ENGINEER'S SUPPLEMENTAL INSTRUCTIONS NO. THIRTEEN (13)
(Via Posting to FTP Site and Electronic Mail)

RE: Harold D. Thompson Regional Water Reclamation Facility (HDTRWRF)-Phase 1
ENGINEER'S SUPPLEMENTAL INSTRUCTIONS NO. THIRTEEN (ESI-013)

This ESI-013 is issued to provide direction for the placement of electrical duct banks and conduit extending from the Equipment, Maintenance and Storage Building electrical room. The modified drawings include EEM-1 issued with the foundation drawings for the Equipment, Maintenance and Storage Building, as well as modified drawings identified as ED-1, ESP-1 and ESP-2. These drawings reflect the discussion and decisions made at the October 6, 2011 meeting at the HDTRWRF. Please note that it was decided at that meeting to place the electrical/control conduits as the "highest" buried utility. The Construction Note on Sheet EEM-1 and the Typical Trench Details on Sheet ESP-2 provide expanded detail regarding this approach.

FOUNDATION ELECTRICAL PLAN
SCALE: 1/4" = 1'-0"

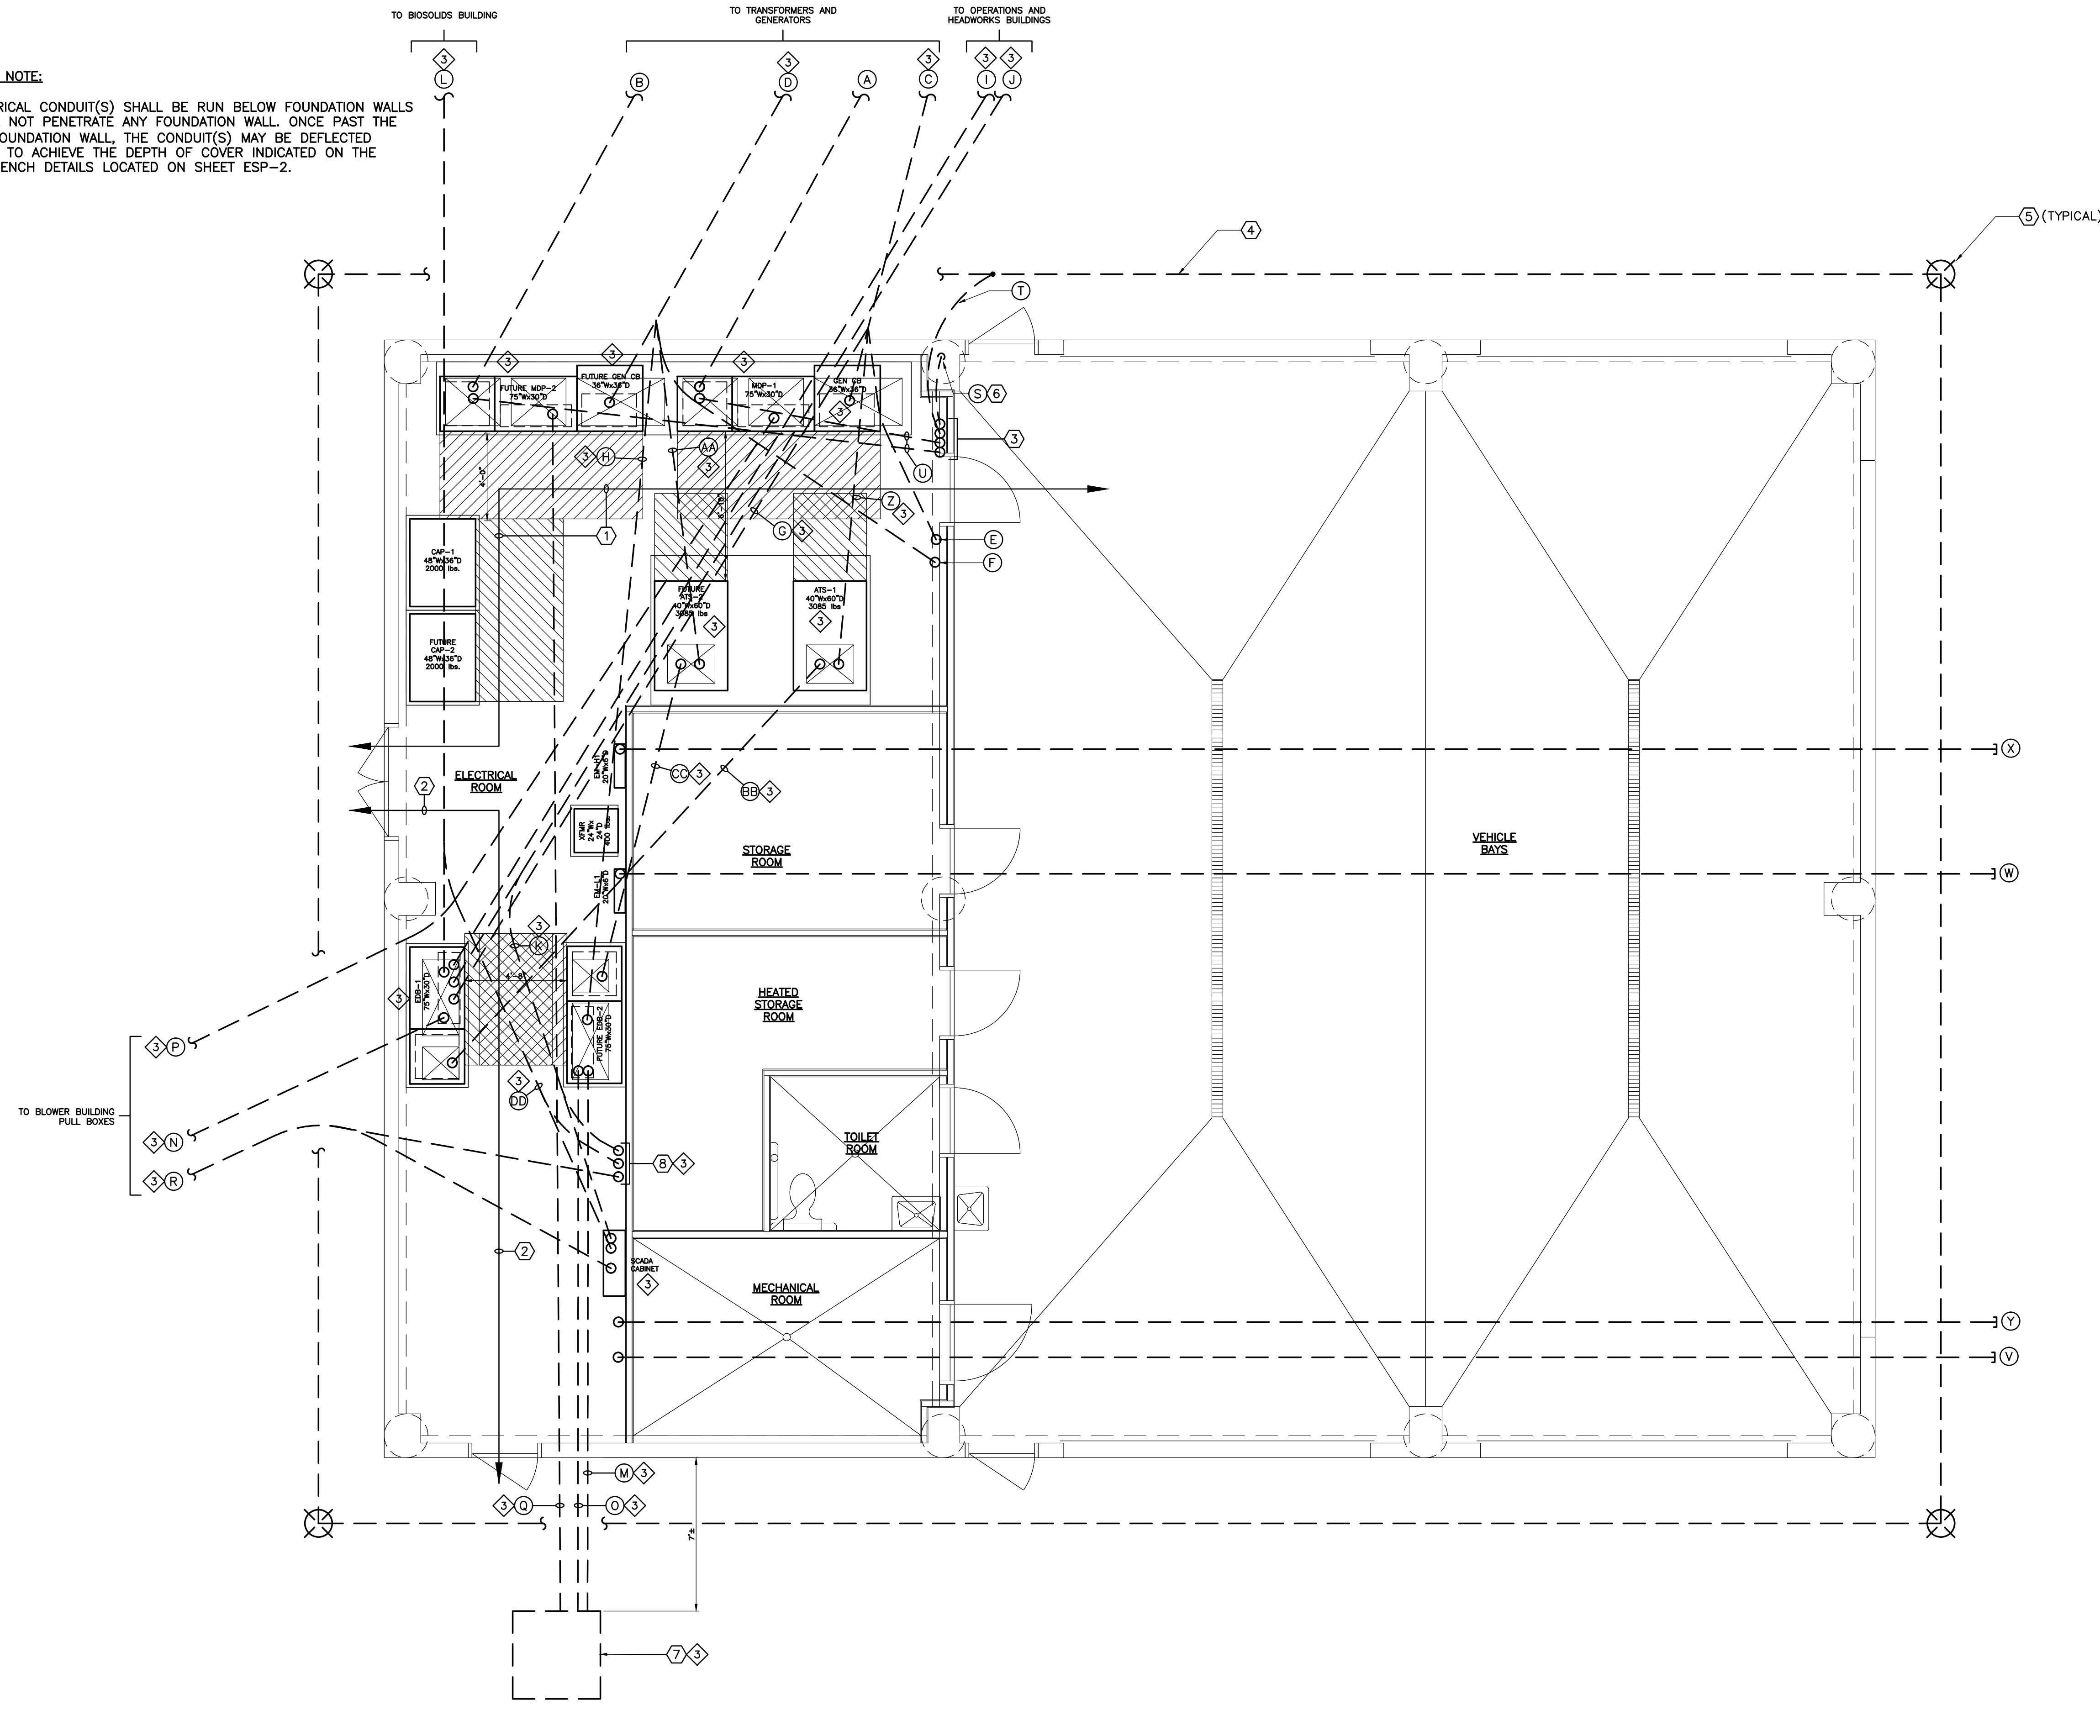
1. ALL ELECTRICAL CONDUIT(S) SHALL BE RUN BELOW FOUNDATION WALLS AND SHALL NOT PENETRATE ANY FOUNDATION WALL. ONCE PAST THE FACE OF FOUNDATION WALL, THE CONDUIT(S) MAY BE DEFLECTED VERTICALLY TO ACHIEVE THE DEPTH OF COVER INDICATED ON THE TYPICAL TRENCH DETAILS LOCATED ON SHEET ESP-2.
